The Legacy Way project (formerly known as Northern Link Road Tunnel)

## **Coordinator-General's report on a project change, number 3**

August 2011

Figure 1.1 Proposed construction workforce parking area: Scenic Drive car park

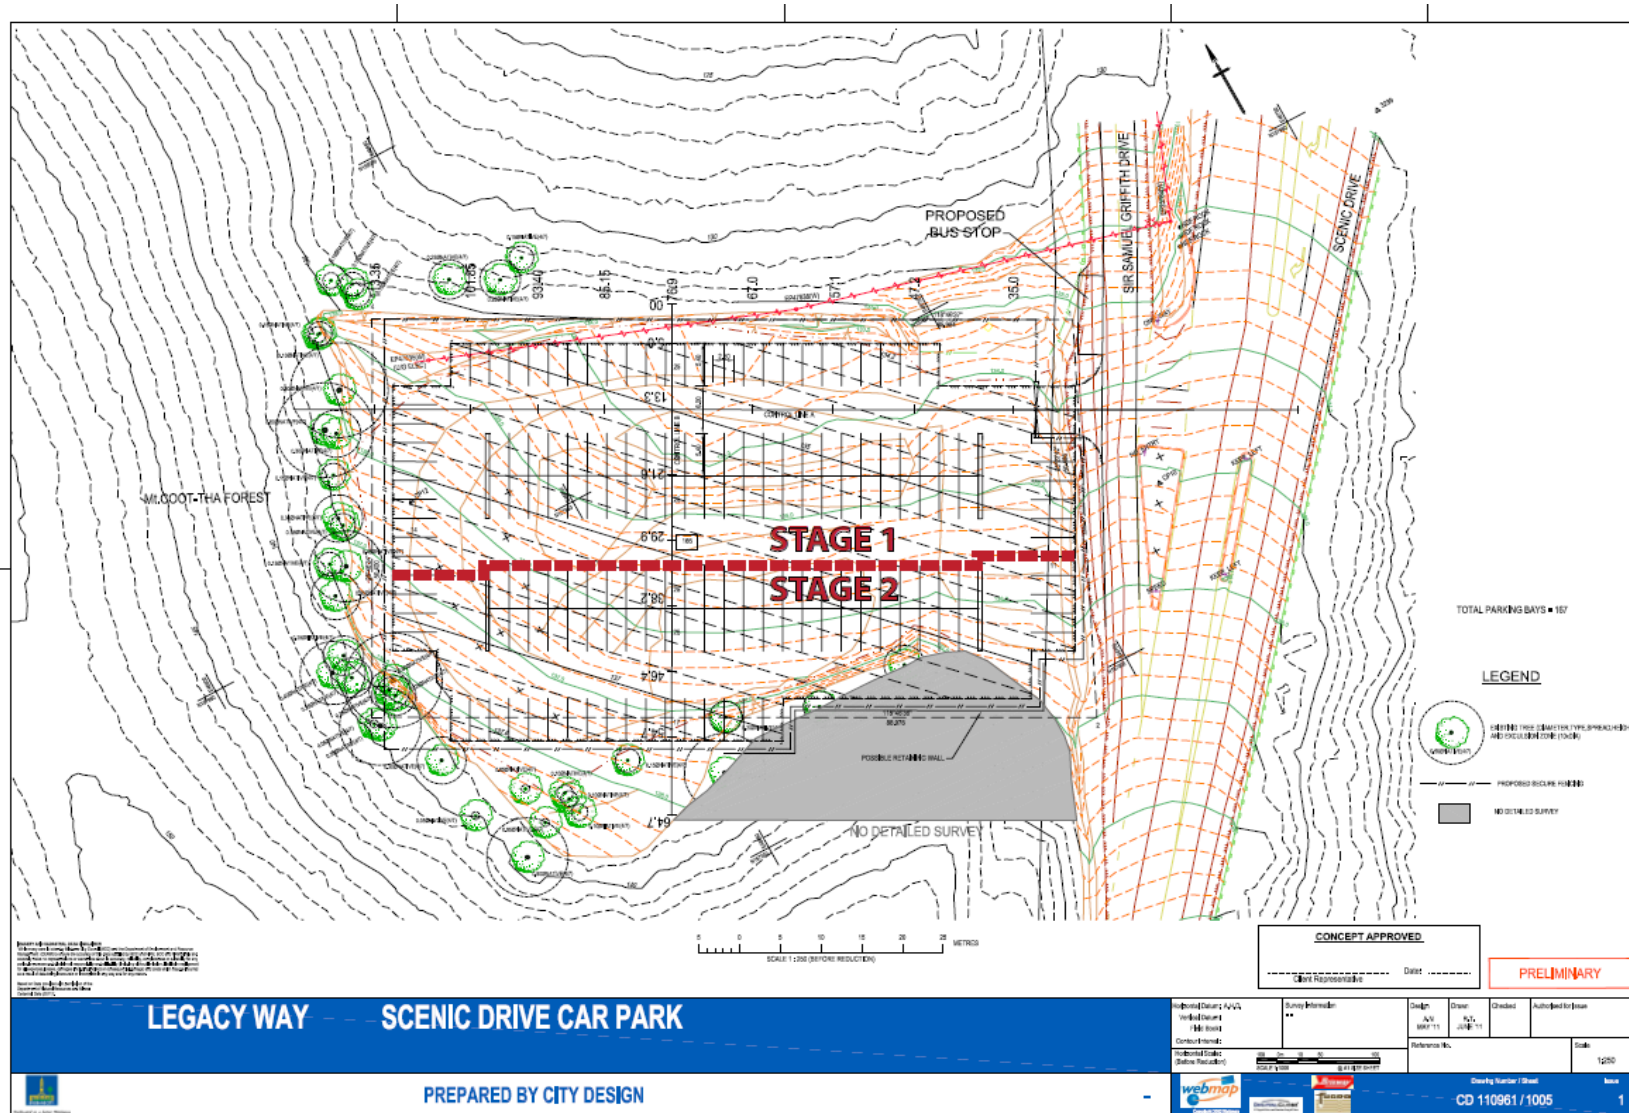
The APC states that, for the single Scenic Drive site option, as a result of the findings and recommendations of the audit, the design of the car park and the entry and exit have been modified to reduce the risk of disruption to road users.

Changes made included incorporating a combined entry/exit access point at the eastern corner of the car park (that is, the point furthest away from traffic descending from the summit) to maximise drivers' sight distance when entering and exiting the car park, particularly of oncoming traffic travelling from the summit.

While the APC states that intersection treatments (including improved lighting and line marking) will seek to address cyclist safety, a further road safety audit will be undertaken when the car park's detailed design is completed, to confirm if leaving access to Sir Samuel Griffith Drive open for continued use by cyclists is acceptable.

(a) The proponent is required to upgrade the intersection of Sir Samuel Griffith Drive and Scenic Drive, including pavement, kerbing, signage, line marking, clear sightlines and lighting to provide safe, legible and convenient connections for pedestrians, cyclists, motorists and car park users to and from all areas adjacent to the car park.

(b) From where road users have line-of-sight to the Scenic Drive car park access on the descent from the Mount Coot-tha summit, the road is to be assessed by Brisbane City Council to determine if any improvements (for example, surfacing) are required, and such works are to be completed.

**Figure 2.1 Superseded Scenic Drive proposal—two areas**

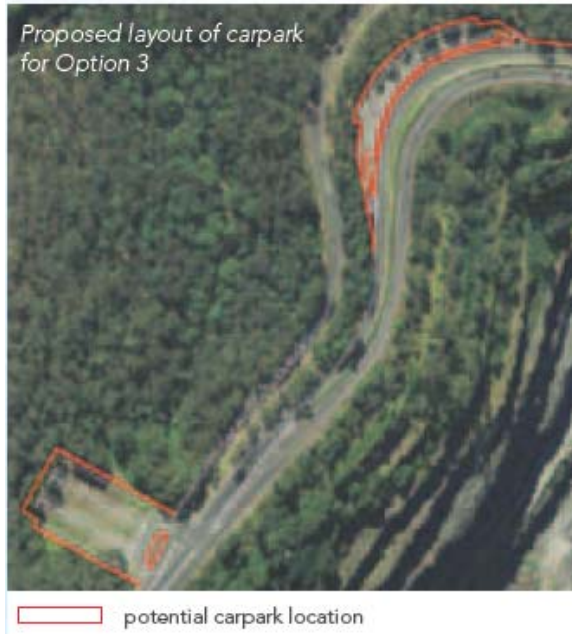
The Scenic Drive option evaluated by BCC in early 2011 differs from the proposal included in the APC dated 24 June 2011. Initially, the Scenic Drive option included parking in two separate areas, with the larger of the two areas being a cleared space that has been used for disaster management purposes, and a smaller area located nearby that would be developed on a road shoulder. The two areas are shown in Figure 2.1.

The APC confirms that the smaller road shoulder area will not be used, largely because of the potential for community impacts due to the temporary loss of the area's amenity.

In acknowledging the area is frequently used by the public to enjoy views to the city, BCC's car park option investigation report, produced at the end of its assessment process, recommended only the larger area of the Scenic Drive option be progressed.
